# Sumter City-County Planning Commission

January 28, 2015

## MSP-14-48/HCPD-15-01, 585 Bultman Dr. & Kilgo St. – Grocery Store & Gas Station (City)

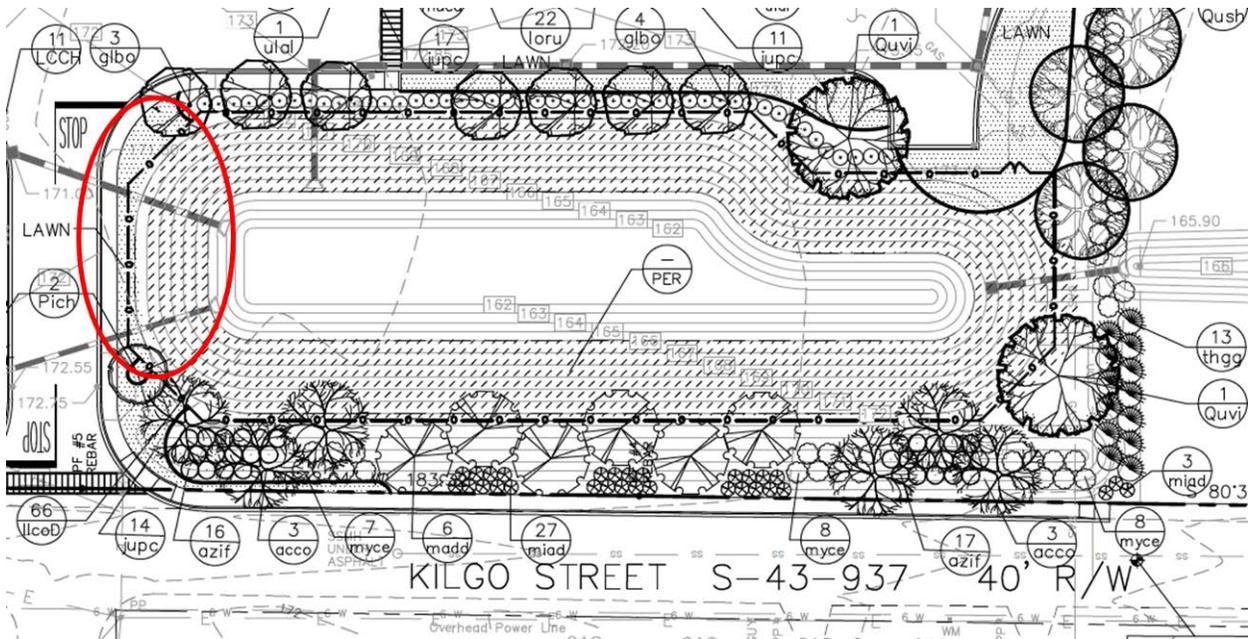
The stormwater management area will be a wet pond located along the Kilgo St. frontage. In accordance with *Section 9.c.5*, items 'd', the applicants intend to provide a fence around the pond for safety reasons. As proposed, this fencing is to be black vinyl dipped chain link. As shown in the graphic below, the landscaping plan does not provide adequate screening around the detention pond to obscure the fence.

With the exception of the area indicated in red in the graphic above, this landscape plan meets the requirements and intent of the Ordinance. The applicant has been made aware of this deficiency and is reviewing plan revisions to properly screen the stormwater management area.

- Submission of revised landscape plan that addresses the stormwater management area to screen proposed fencing.
- Final approval and issuance of all appropriate encroachment permits from SCDOT prior to issuance of construction permits.

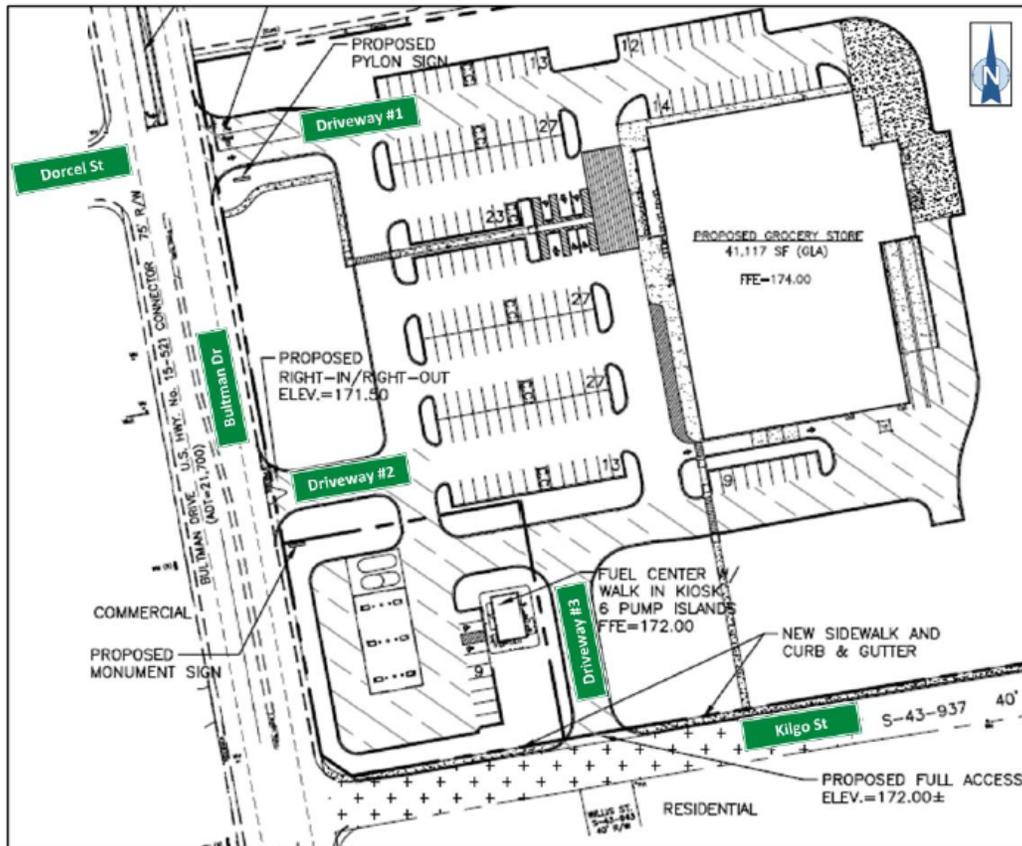
As shown in the graphic above, there are three driveways proposed to access the site: two on Bultman Dr. (Driveway #1 and #2) and one on Kilgo St. (Driveway #3). The north driveway (Driveway #1) on Bultman Dr., located opposite Dorcel St., is proposed for full access. The south driveway on Bultman Dr. (Driveway 2) located between Kilgo St. and Dorcel St. is proposed as right-in/right-out only. The driveway on Kilgo St. (Driveway 3) is proposed for full access.

The following improvements are recommended by the TIS and illustrated in the figure on the following page.

1. Install traffic signal control at the intersection of Bultman Dr. and Dorcel St./Proposed Driveway #1. All left turns should operate in permissive mode (no protected left turns.)

2. At Bultman Dr. and Dorcel St. provide the following geometry:
  - a. With traffic signal control, the first internal driveway should be separated from Bultman Dr. by a minimum of 150 ft.

- b. Restripe the median between Dorcel St. and Gayle St. to accommodate a 150 ft. southbound left turn lane.
  - c. On the westbound approach of Driveway #1 (opposite Dorcel St.), provide a continuous left turn lane and 125 ft. thru/right combination lane.

3. At the right-in/right-out driveway on Bultman Dr. (Driveway #2) provide a 100 ft. northbound right turn deceleration lane.
4. The site access on Kilgo St. (Driveway #3) should align directly across from Willis St.

5. Provide 50 ft. turning radii on all exterior driveways.

Planning Staff agrees with these findings and recommendations. The applicant has submitted the TIS to SCDOT and is awaiting comment/approval. The development plans are currently being revised to show implementation of the recommended mitigation measures outlined above. Design and configuration of the proposed traffic signal at Bultman Dr. and Dorcel St. will be fully developed after final comment from SCDOT.

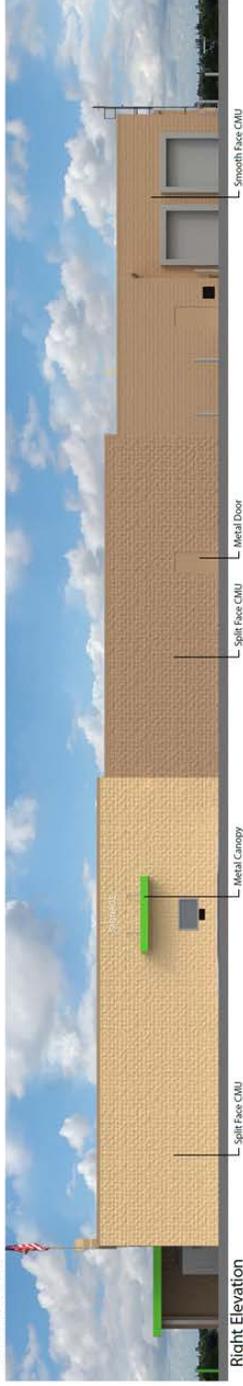
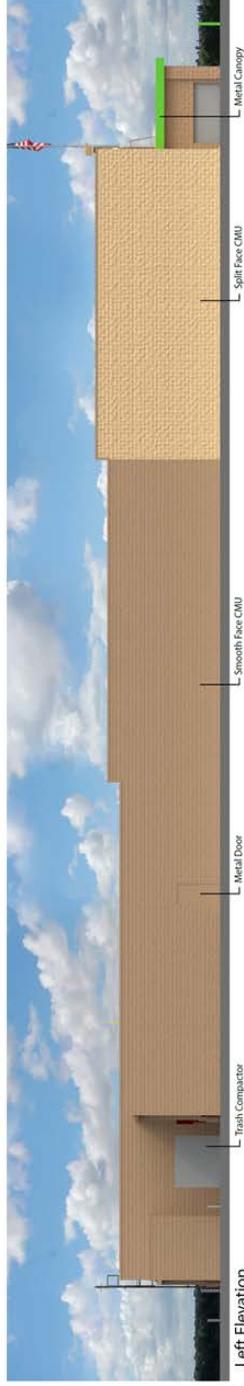
There are three structures proposed for this development – the grocery store, the convenience store kiosk, and gas canopy. Building Elevations have been attached to this report. The exterior of the buildings will be a blend of split face CMU, smooth face CMU, EIFS and metal canopies. The proposed elevations are shown on the following pages. The primary building colors are earth tones with green accents on the metal canopies.

The proposed roof pitch is complementary to and compatible with the existing smaller commercial structures in this area,
